ALLISON 1000/2000 SERIES TRANSMISSIONS MODULATED LINE PRESSURE

CHANGE: Beginning with June 2003 production, a *Modulated Main Line Pressure* feature has been added to the Allison 1000/2000 series of transmissions.

Figure 1

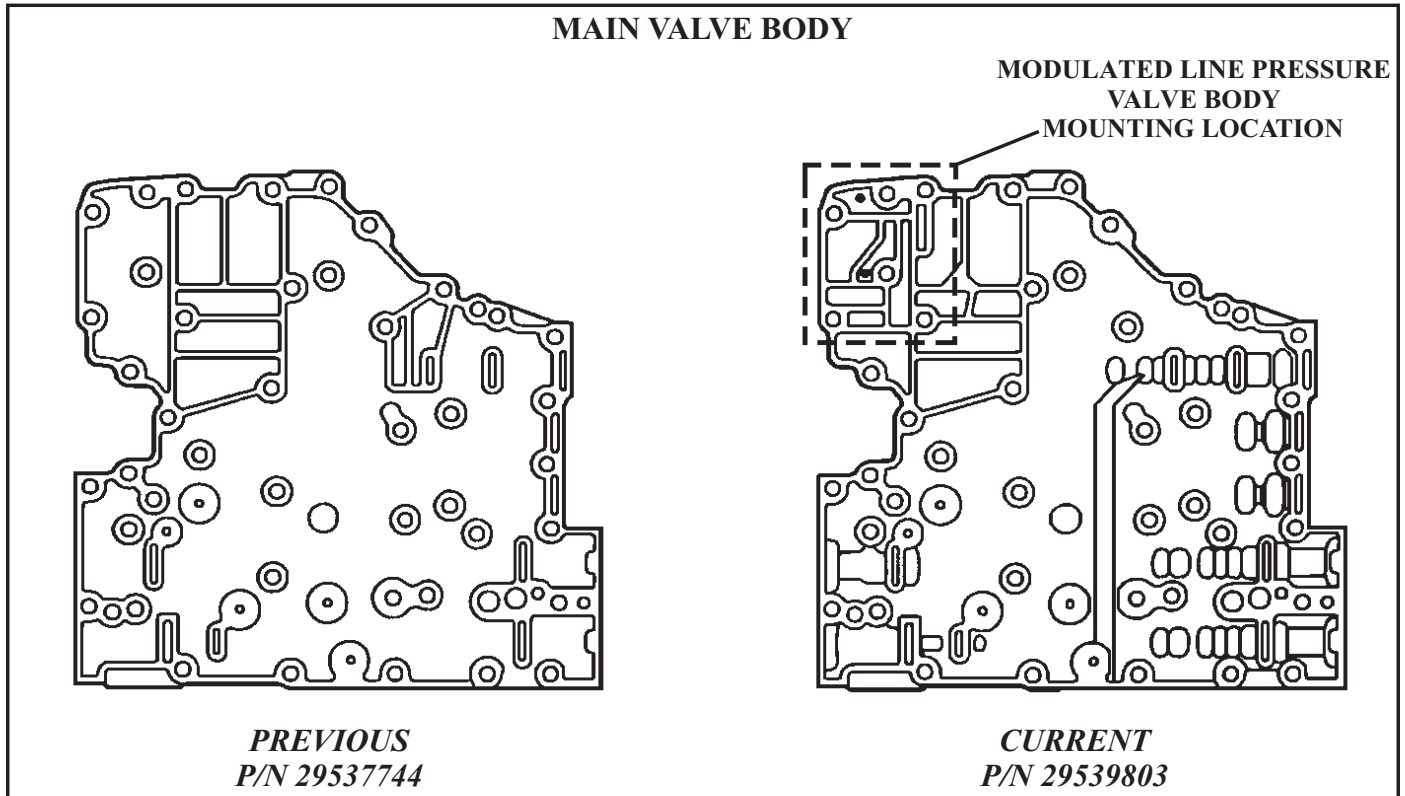
- (1)The Main Valve Body, (Figure 1), has changed as well as the Separator Plate, (Figure2).
- (2)The Shift Valve Body has changed, (Refer to Figures 3 and 4).

Figure 5

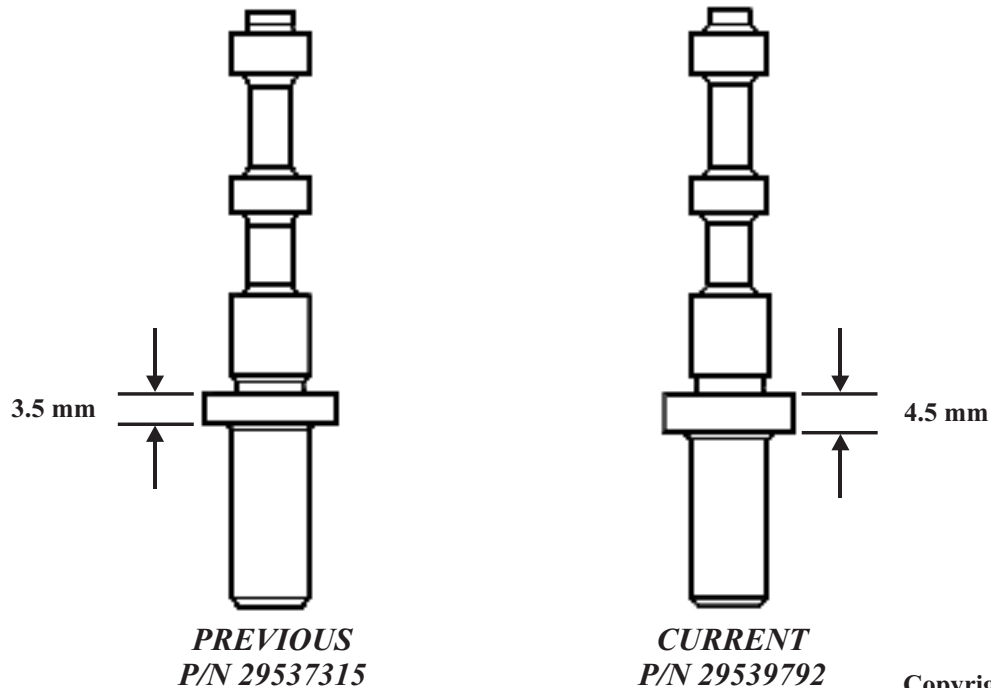
- (3)The Control Main Regulator Valve has changed, (See Figure 5).
- (4)The Main Pressure Regulator Valve has changed depending on application as shown in Figure 6.

Figure 7

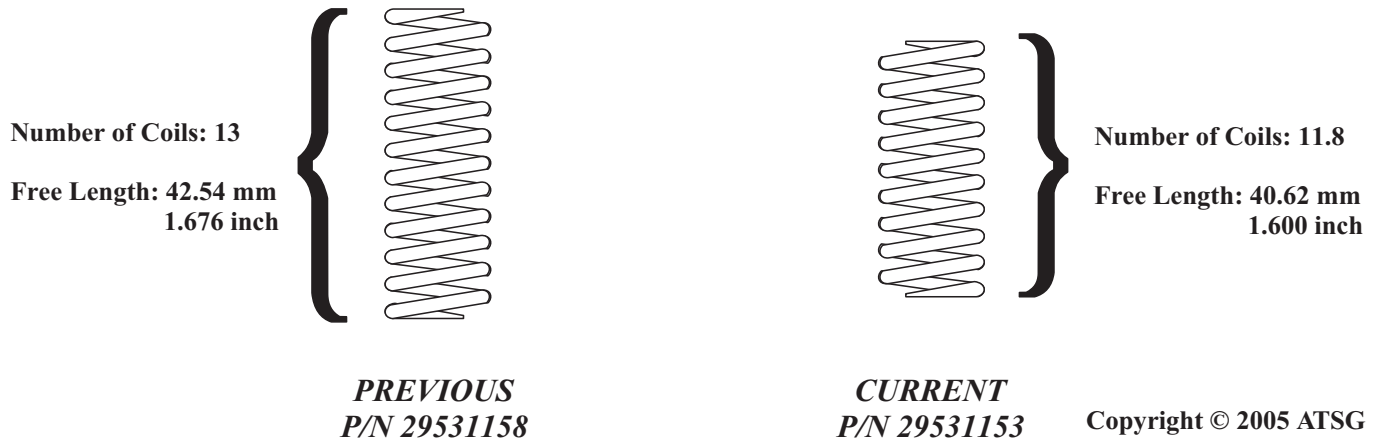
- (5)The Control Main Regulator and Control Main Relief Springs have changed demensionally as shown in Figure 7.
- (6)A Modulated Main Valve Body has been added to accommodate the “G” Solenoid as seen in Figure 8).

Figure 9

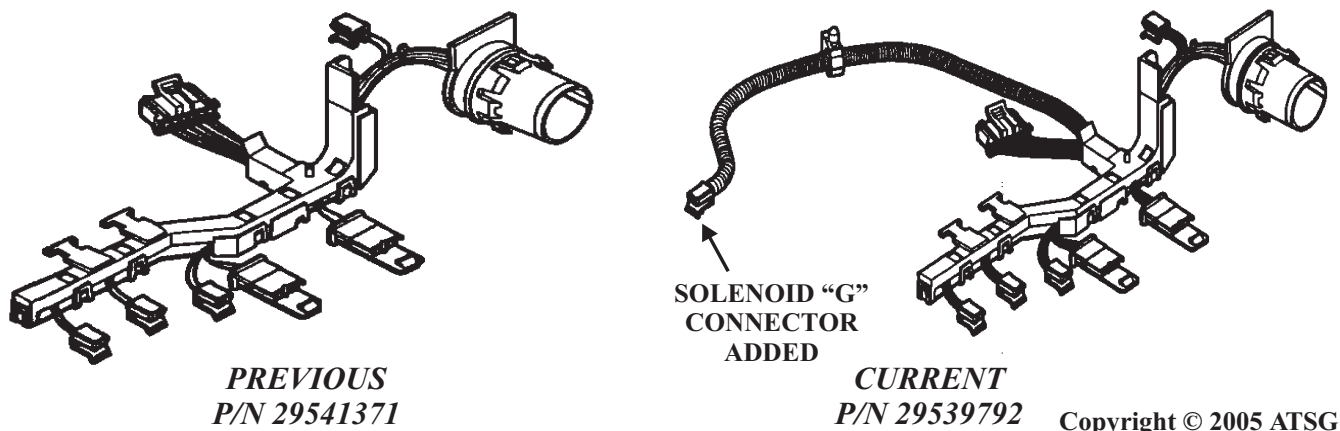
- (7)The internal wiring harness has been changed to accommodate the “G” Solenoid, (See Figure 9).
- (8)This feature also includes the addition of Solenoid “G” as well as the additional circuitry from case connector terminal “R” to the “J2” (RED) TCM connector at terminal 30 as shown in Figure 10.
